## Agar Grove Phase 1c

Air Source Heat Pump Design - Comparison

## Phase 1c - Approved and Minor Material Ammendment

## Block I - North/South Elevations

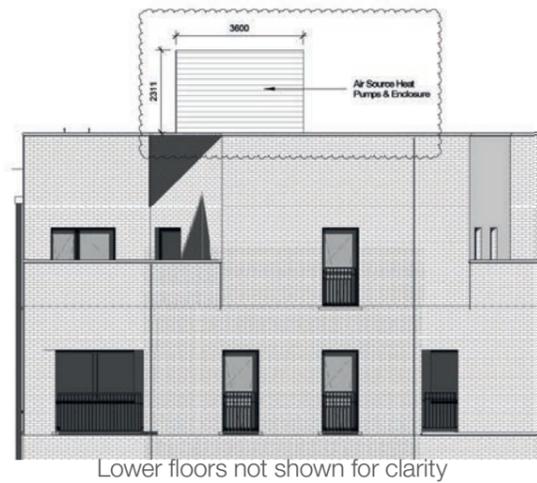
ASHPs and enclosure - Approved October 2020  
South Elevation

ASHPs and enclosure - Approved October 2020  
North Elevation

ASHPs and enclosure - Proposed Minor Material Amendment February 2023  
South Elevation

ASHPs and enclosure - Proposed Minor Material Amendment February 2023  
South Elevation

## Block I - West Elevation

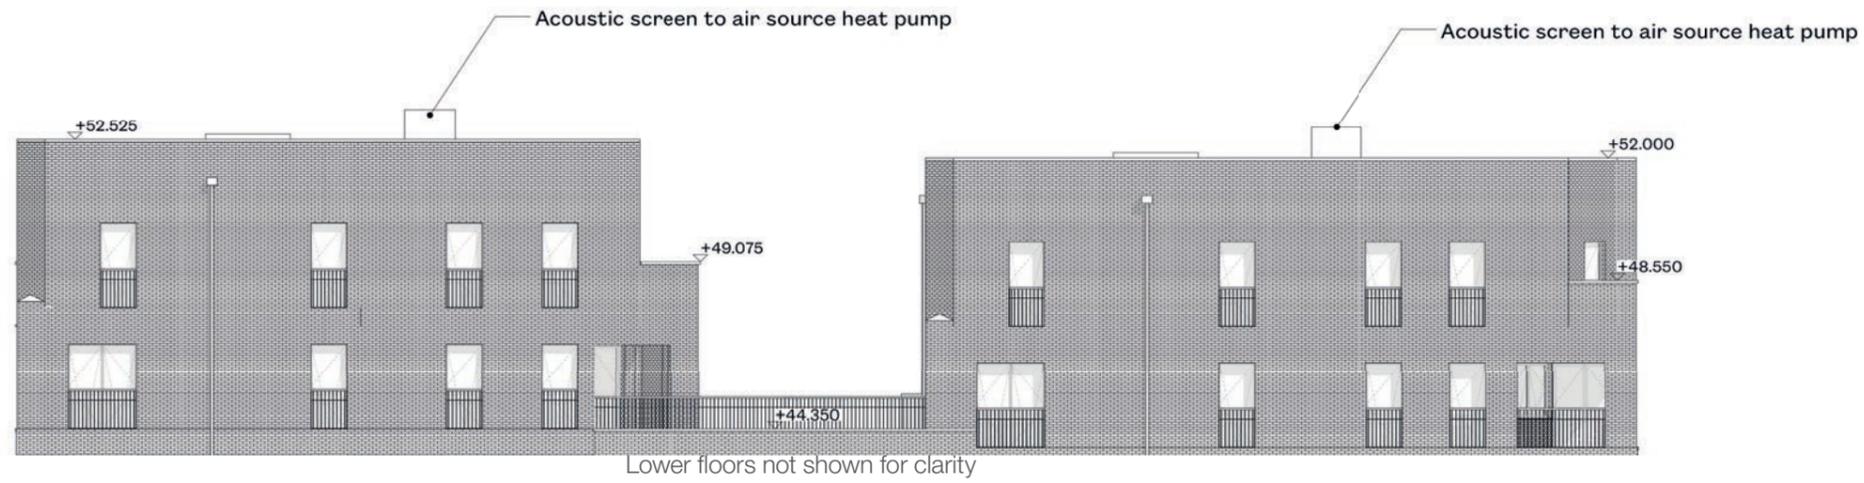
ASHPs and enclosure - Approved October 2020  
West Elevation

ASHPs and enclosure - Proposed Minor Material Amendment February 2023  
West Elevation

## Block JKL - East/North Elevations

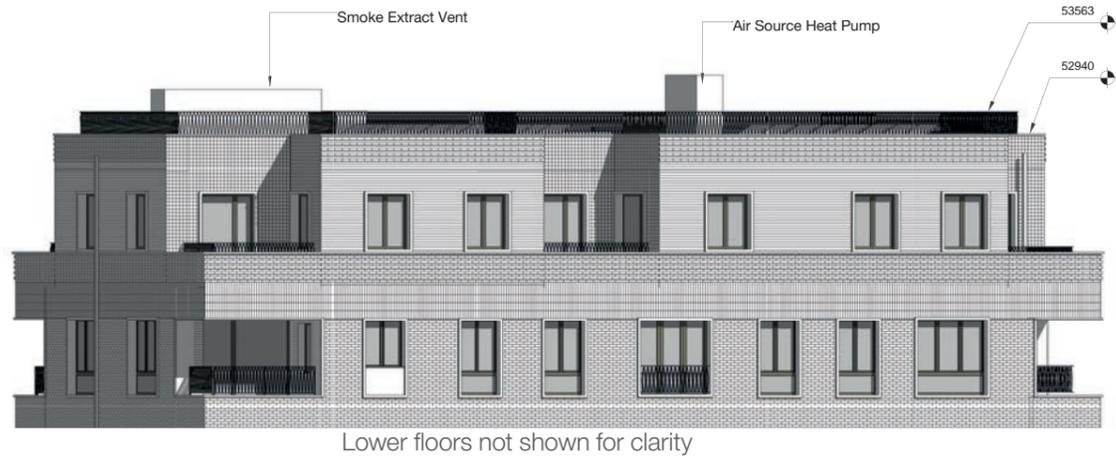
ASHPs and enclosure - Approved October 2020  
East Elevation

ASHPs and enclosure - Approved October 2020  
North Elevation

ASHPs and enclosure - Proposed Minor Material Amendment February 2023  
East Elevation

ASHPs and enclosure - Proposed Minor Material Amendment February 2023  
North Elevation

## Block JKL - West Elevation

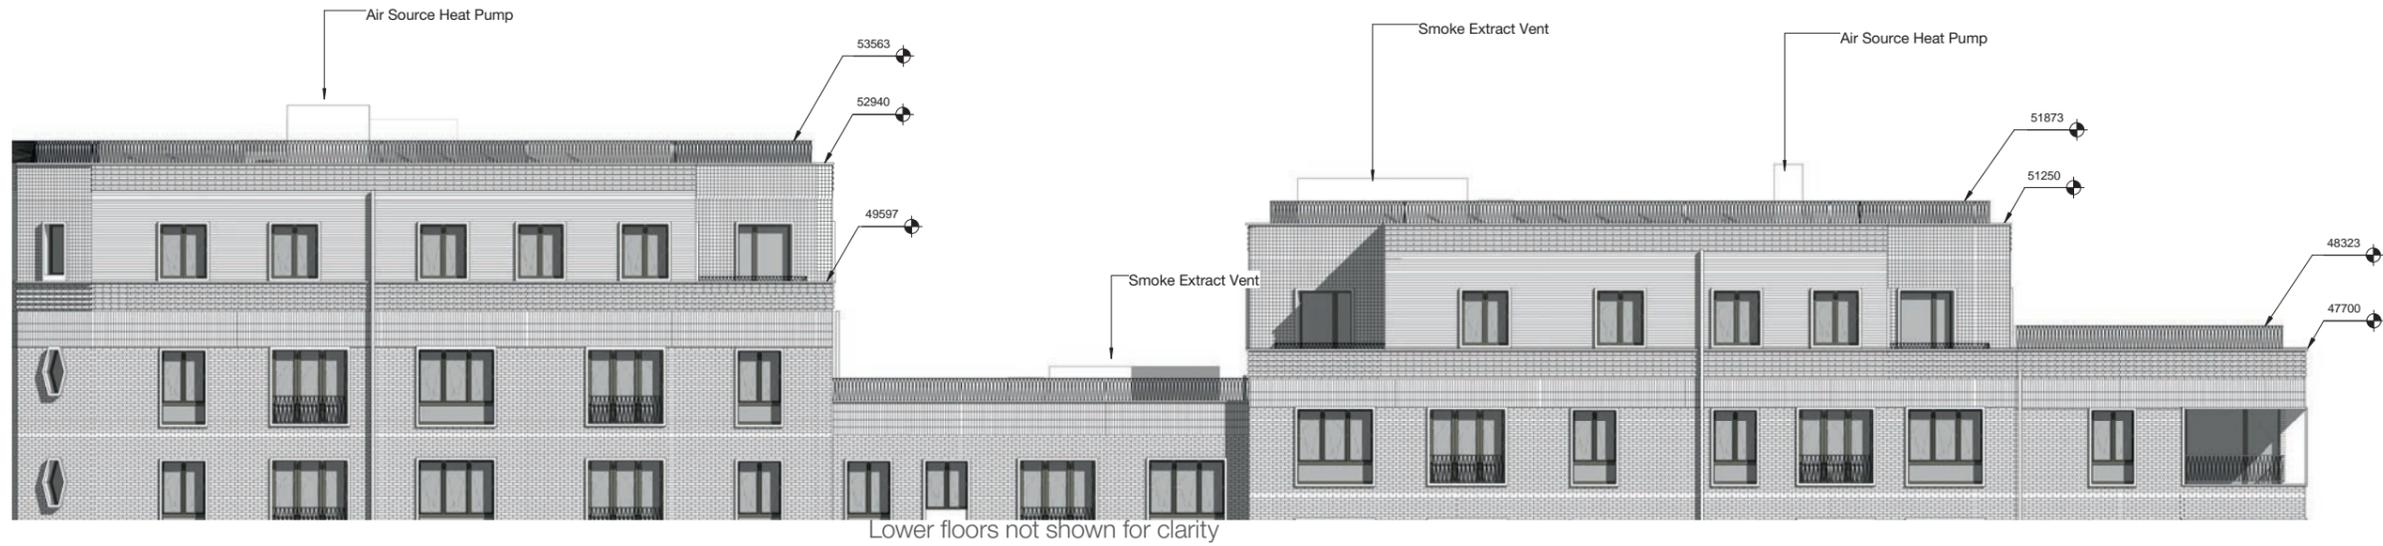
ASHPs and enclosure - Approved October 2020  
West Elevation

ASHPs and enclosure - Proposed Minor Material Amendment February 2023  
West Elevation

## Block JKL - South Elevation

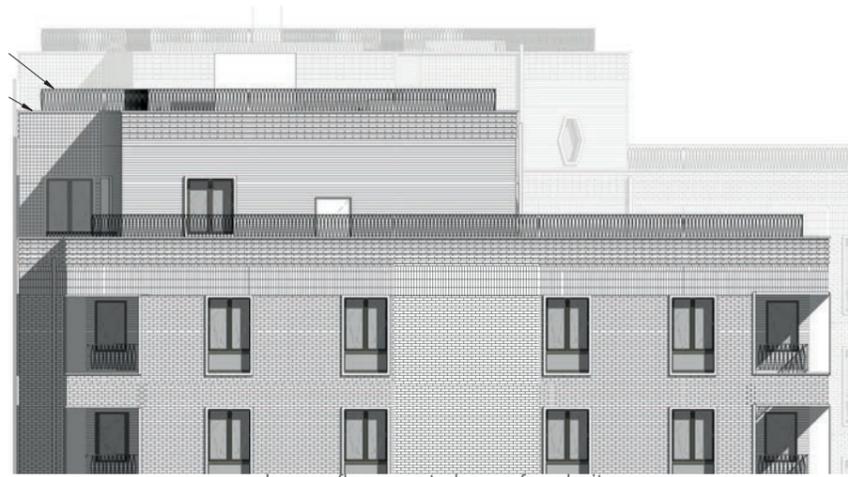
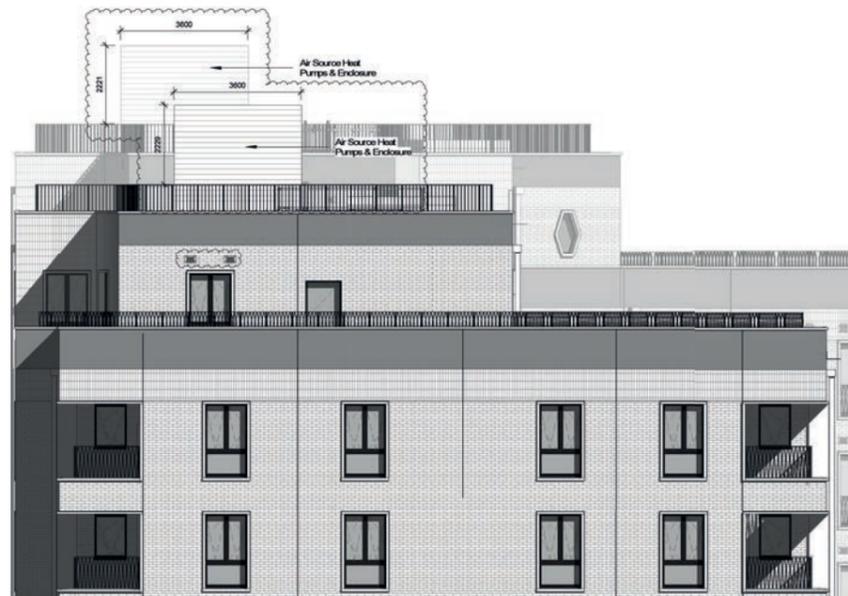
ASHPs and enclosure - Approved October 2020  
South Elevation

ASHPs and enclosure - Proposed Minor Material Amendment February 2023  
South Elevation

## Block JKL - RAL Colours

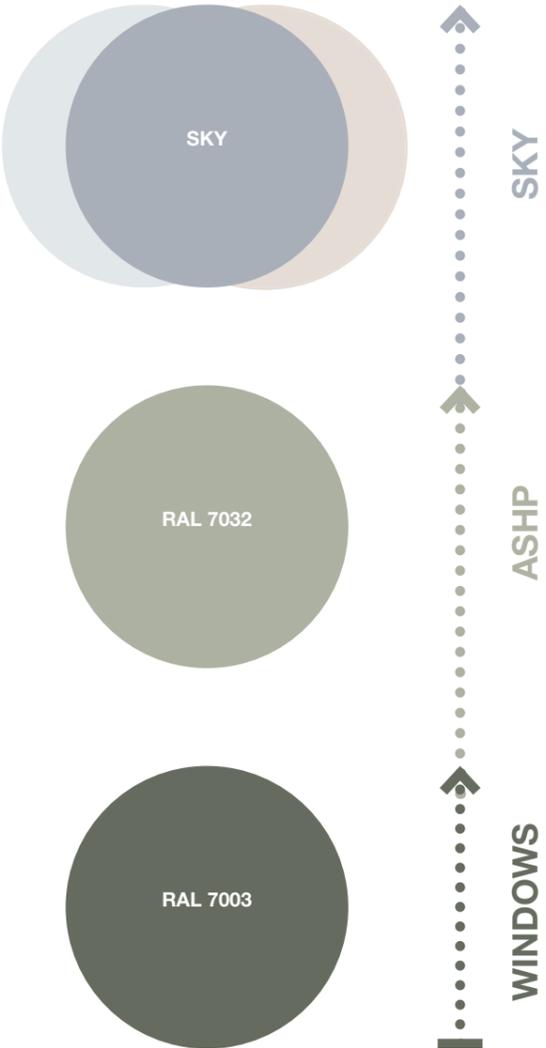
The ASHP will be clad in a metal finish to the colour of RAL 7032.

On Block JKL which has a window frame & sash colour of RAL 7003, the RAL 7032 of the ASHP is a softer tone which conforms to the varying neutral blues and greys of the sky.

There were options to use the RAL colour of the windows on the ASHP, however this made the ASHP stand out more vividly in test renders, whilst the RAL 7032 was a softer green tone and created a natural vertical fade up the elevation.

## Block I - RAL Colours

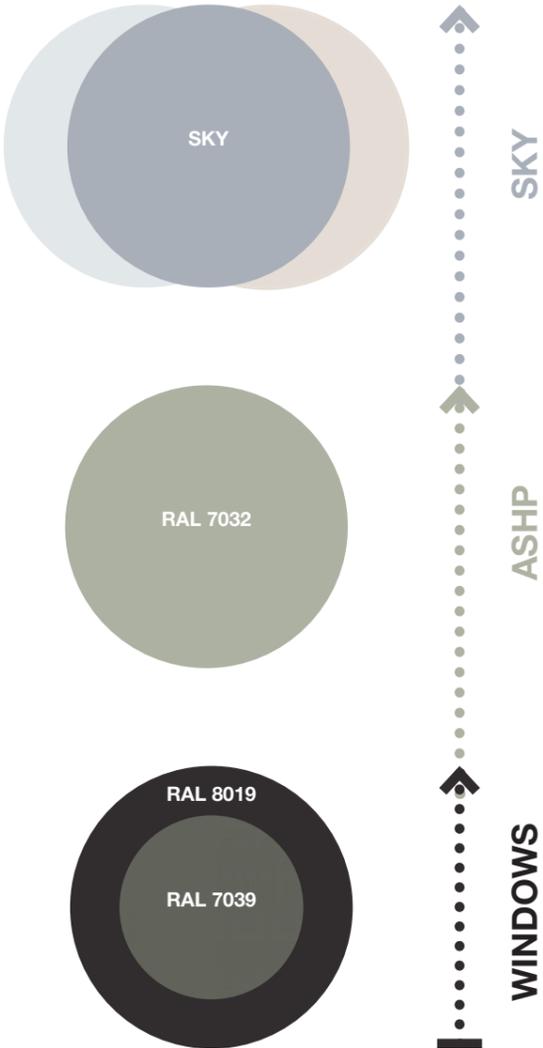
The ASHP will be clad in a metal finish to the colour of RAL 7032.

On Block I which has a window frame colour of RAL 8019 & a sash colour of 7039, the RAL 7032 of the ASHP is a softer tone which conforms with the varying neutral blues and greys of the sky.
